**Addendum to the Groundwater Flow Model
for the Central Carbonate-Rock Province:
Clark, Lincoln, and White Pine Counties
Groundwater Development Project**

DRAFT

August 2010

Figure 4-2
Spatial Distribution of Upper-Valley-Fill Transmissivity
Simulated by the Modified Numerical Model

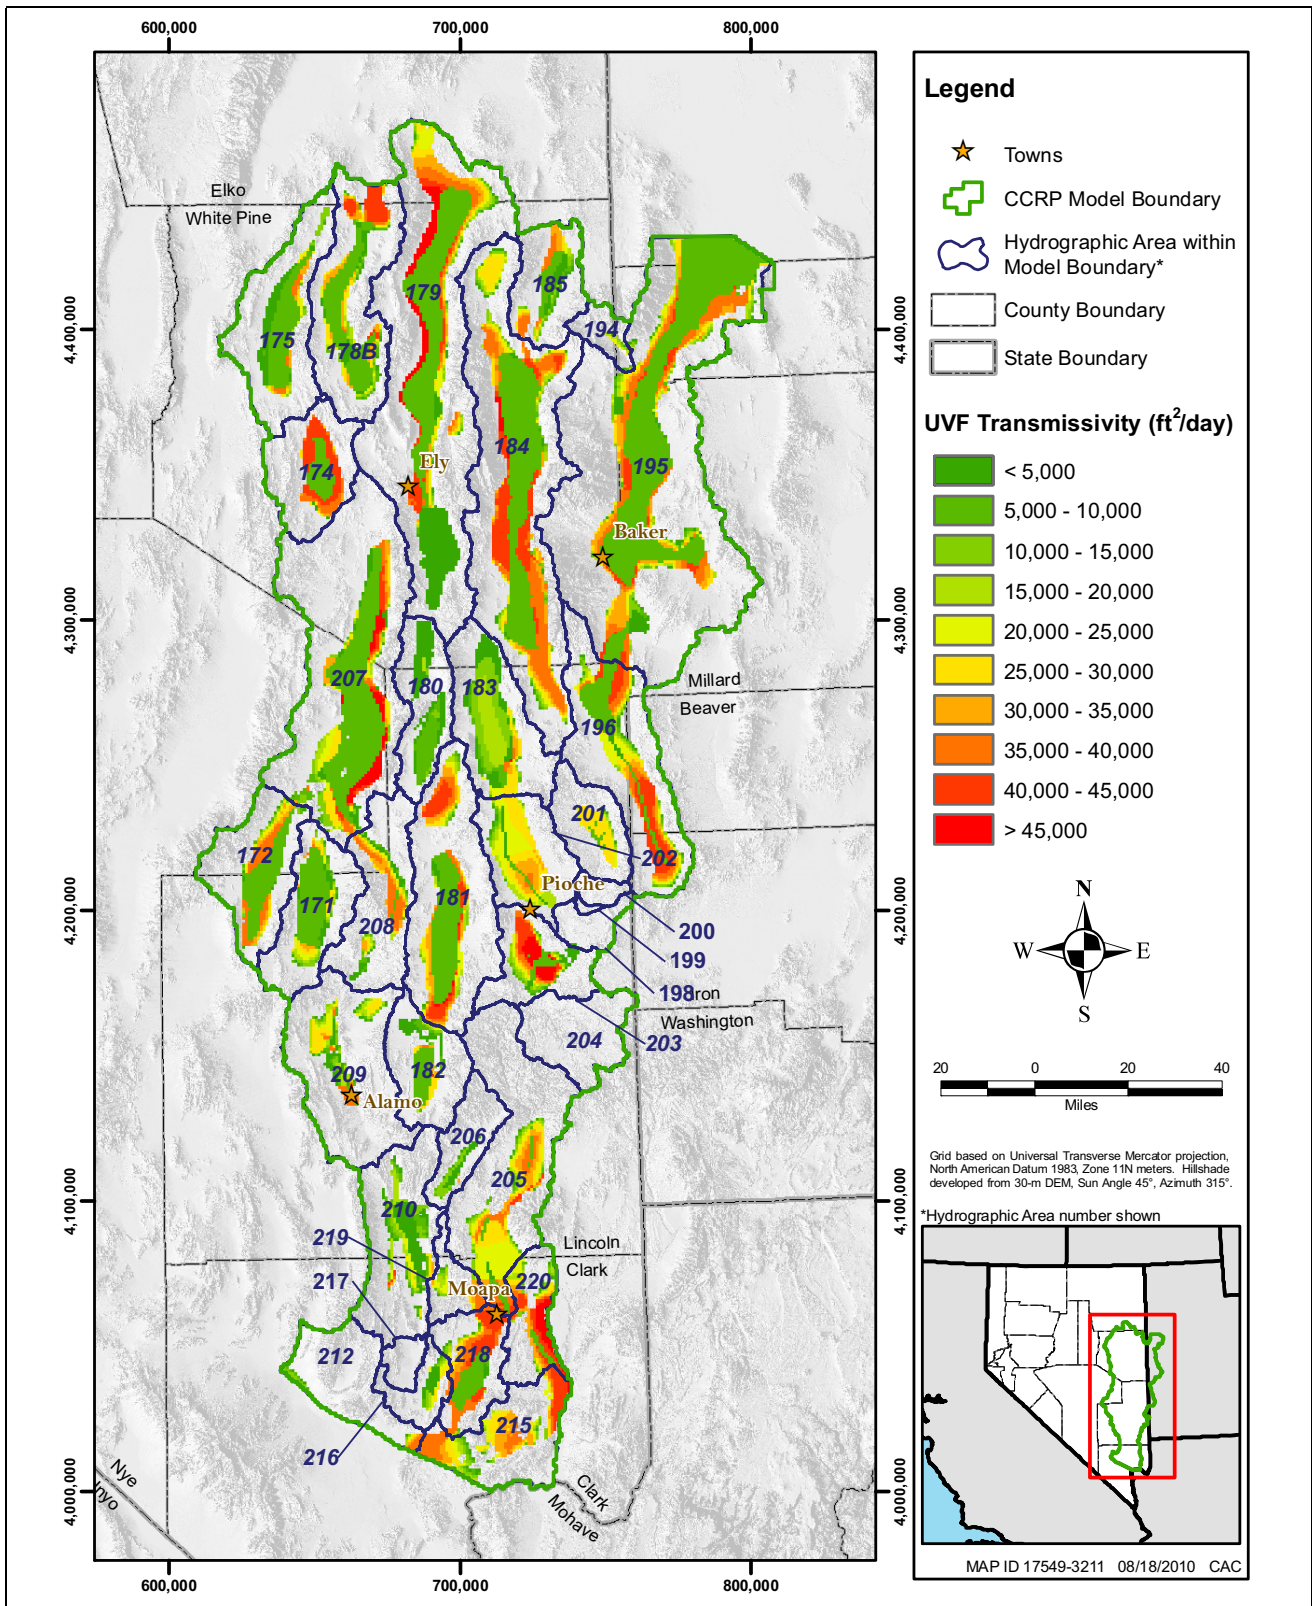
As requested by the BLM reviewers, a map of the total transmissivity of the model including the effect of the decrease of horizontal hydraulic conductivity with depth is presented in [Figure 4-2](#).
